# URGENT MEDICAL DEVICE CORRECTION

GE HealthCare Ref. # 32089

RE: **Giraffe OmniBed and Giraffe OmniBed Carestation potential incorrect secondary latch installed on certain bedside panels.**

**Figure 1. Bedside Panels showing Northeast (NE) and Northwest (NW) latches**

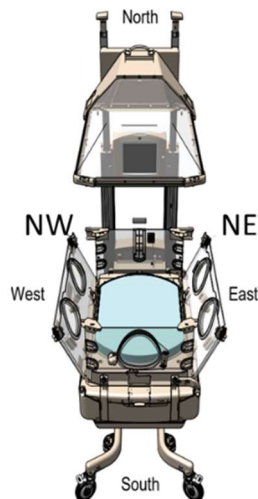
GE HealthCare has become aware of the potential that an incorrect type of secondary latch could have been installed on the northeast (NE) and/or northwest (NW) bedside panels for certain Giraffe OmniBed and Giraffe OmniBed Carestation devices (see figure 1).

The secondary latch mechanism serves two functions: (1) acts as a “catch” and reduces the potential for the bedside panel to fall if the user does not latch the primary latch mechanism correctly and (2) keeps the north wall in place when the canopy is raised.

For devices that have the incorrect type of secondary latch installed, the north wall can potentially become disengaged when the canopy is raised. However, the device

is designed such that the panels will stay closed and function as intended, even if only the primary latches on the south end are properly engaged.

GE HealthCare will replace all affected latches at no cost to you.  
A GE HealthCare representative will contact you to arrange for replacing any incorrect latches.

Figure 2. North end bedside panel latch locations

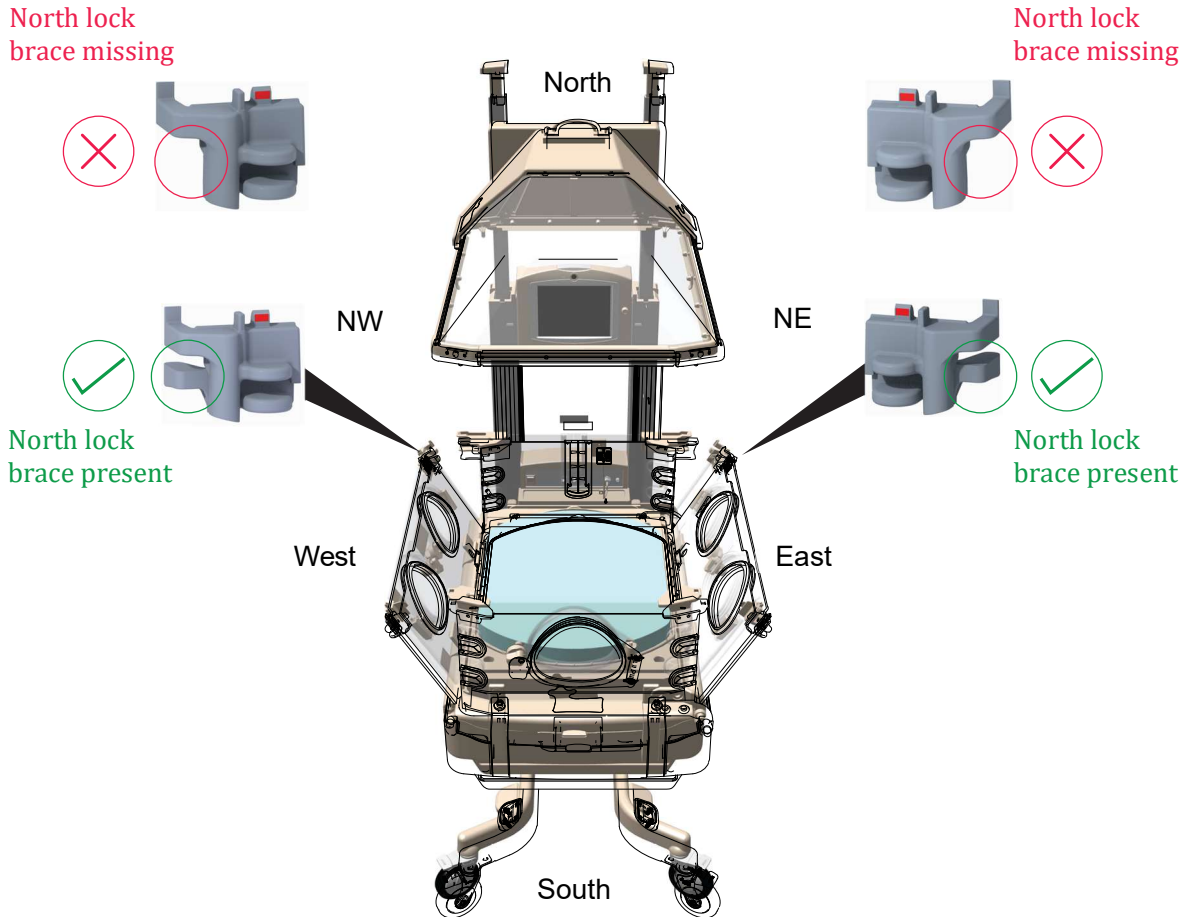
1. Visually inspect the NW and NE bedside panel latch assemblies on all Giraffe OmniBeds and Giraffe OmniBed Carestations to ensure the correct latches are present (See Figure 2).

2. If an incorrect latch is found quarantine the device.
3. Inspect any field replaceable bedside panel stock at your facility per Figure 2 for the parts #'s listed below to ensure the correct latches are present and quarantine any field replaceable bedside panels with incorrect latches.
  - 5865384-01 to 5865384-34,
  - 5865385-01 to 5865385-34,
  - 5865386-01 to 5865386-34 and
  - 5865387-01 to 5865387-34
4. Record the results of the inspections on the provided Medical Device Notification Acknowledgement Response Form and send this form to GE HealthCare at [MIC.FMI32089@ge.com](mailto:MIC.FMI32089@ge.com)
5. GE HealthCare will contact you to arrange for shipment of replacement latches. These will be provided free of charge to you.

6. Once correct latches are received, replace the incorrect latches with the correct latches and dispose of the incorrect latches.
